Access Compliance Report

Public Rights-of-Way

(Curb Ramps)

Intersection ID: 3083	Main Street: LOGANVILLE_DR	Cross Street: PANTHERSVILLE_DR	Location: NW
ADA ID: BED071DA5898	Ramp Type: Perp	Initial Pass/Fail: Fail	Overall Compliance: No
Codes/Mitigation Info/Possible Solution		Field Measurements/Component Compliance	
Severity Score: 36.25

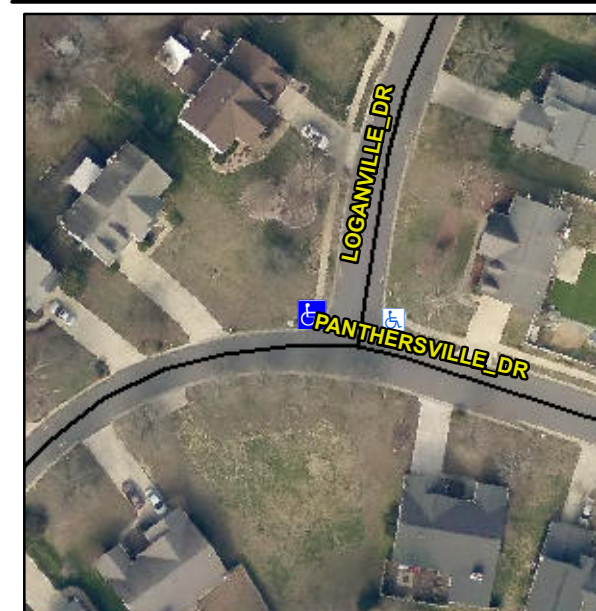
Not Found, R304.5.1, R304.5.3

Compliance	Description	Data	Compliance	Description	Data
N/A	Ramp Length (in)	97.5	Yes	Ramp Slope (%)	5.7
No	Ramp Width (in)	26.5	No	Ramp XSlope (%)	2.5
N/A	Flare Type LT	N/A	N/A	Flare Type RT	N/A
N/A	Flare Slope LT (%)	N/A	N/A	Flare Slope RT (%)	N/A
N/A	Flare Traversable LT?	N/A	N/A	Flare Traversable RT?	N/A
N/A	Landing Length (in)	N/A	N/A	DWS Provided?	N/A
N/A	Landing Width (in)	N/A	N/A	DWS Contrast?	N/A
N/A	Landing Slope (%)	N/A	N/A	DWS Length (in)	N/A
N/A	Landing X Slope (%)	N/A	N/A	DWS Full Width?	N/A
N/A	Landing Curb? (Y/N)	N/A	N/A	DWS Offset (in)	N/A
N/A	Shared Landing?	N/A			
N/A	Gutter Ponding?	N/A	N/A	Gutter Slope (%)	N/A
N/A	Gutter Lip Ht (in)	N/A	N/A	Gutter X Slope (%)	N/A
N/A	Painted X Walk1?	No	N/A	Painted X Walk2?	N/A
	X Walk 1 Direction	To E		X Walk 2 Direction	N/A
N/A	X Walk 1 Width (in)	N/A	N/A	X Walk 2 Width (in)	N/A
	X Walk 1 Slope (%)	3.0		X Walk 2 Slope (%)	N/A
	X Walk 1 X Slope (%)	2.3		X Walk 2 X Slope (%)	N/A

Remove & Replace Entire Ramp.
